Truncation of Gatwick DVR 1M 1V SIDs ACP-2020-51

1. This paper relates to the Gatwick SID truncations which Gatwick, NATS and GAL wish to make concurrently with CAP 1912 implementation to 'smooth out' the impact.

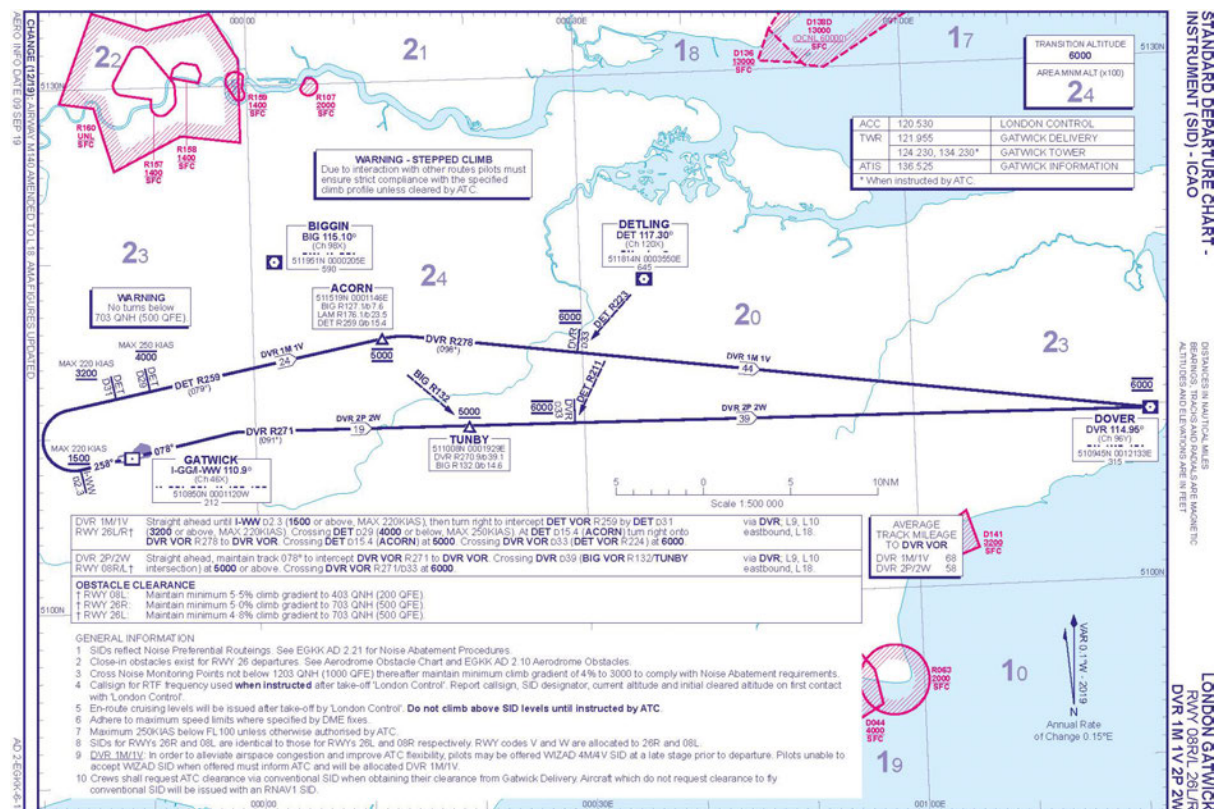
The SoN conforms to the first bullet, as a new ATS route is needed, and to the third and fourth bullets. The sponsor DOES NOT wish to truncate prior to final end altitude or affect lateral profile.
